3.5 LIMITING CONDITION FOR OPERATION

4.5 SURVEILLANCE REQUIREMENT

ATTACHMENT 2

VERMONT YANKEE RHR SYSTEM (LPC) MODE

3.5.A.4

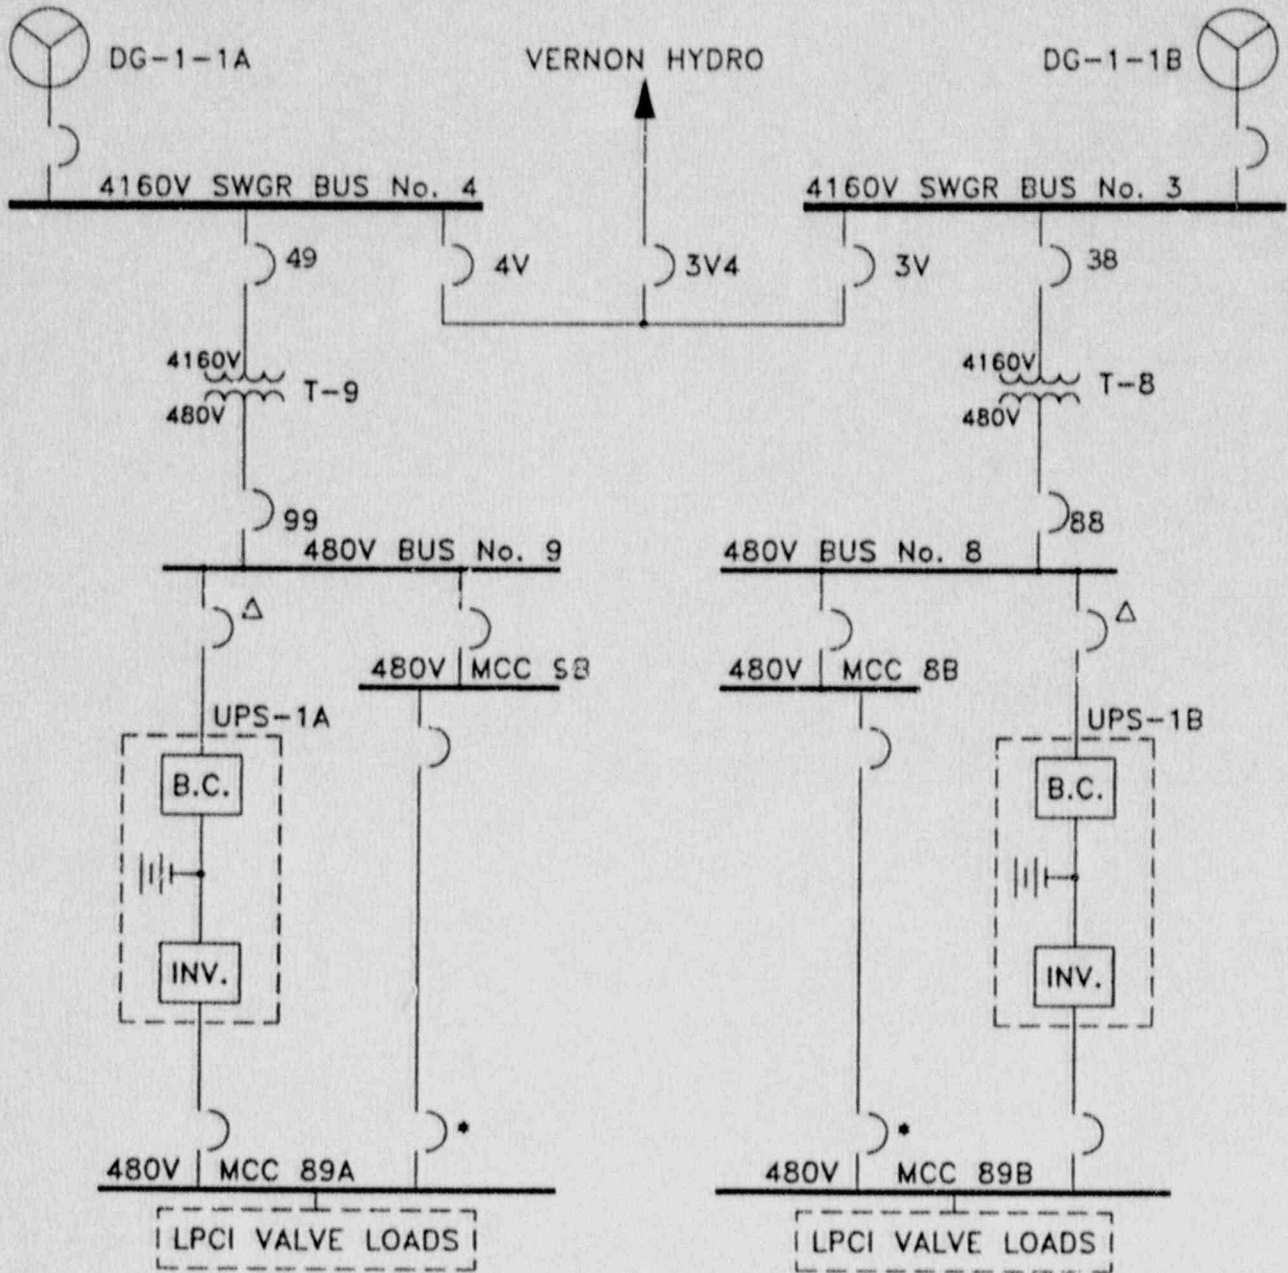
~~4. From and after the date that a LPCI Subsystem is made inoperable for any reason, including the making of such a subsystem inoperable, the active components of the redundant LPCI Subsystem shall have been or shall be demonstrated to be operable within 24 hours (except the Recirculation System discharge valves).~~

~~"Insert attached paragraphs 4.a and 4.b"~~

4. When a LPCI Subsystem is made or found to be inoperable, the active components of the redundant LPCI Subsystem shall have been or shall be demonstrated to be operable within 24 hours (except the Recirculation System discharge valves).

- a. From and after the date that a LPCI Subsystem is made or found to be inoperable due to failure of the associated UPS, reactor operation is permissible only during the succeeding thirty days, for the 1989/90 operating cycle, unless it is sooner made operable, provided that during that time the associated motor control center (89A or 89B) is powered from its respective maintenance tie, all active components of the other LPCI and the Containment Cooling Subsystem, the Core Spray Subsystems, and the emergency diesel generators shall be operable, the requirements of Specification 3.10.A.4 are met, and the 4160 volt tie line to the Vernon Hydro is the operable delayed access power source.

- b. From and after the date that a LPCI Subsystem is made or found to be inoperable for any reason, other than failure of the UPS during 1989/90 operating cycle, or Specification 3.5.A.4.a is not met, reactor operation is permissible only during the succeeding seven days unless it is sooner made operable, provided that during that time all active components of the other LPCI and the Containment Cooling Subsystem, the Core Spray Subsystems, and the diesel generators required for operation of such components if no external source of power were available, shall be operable.
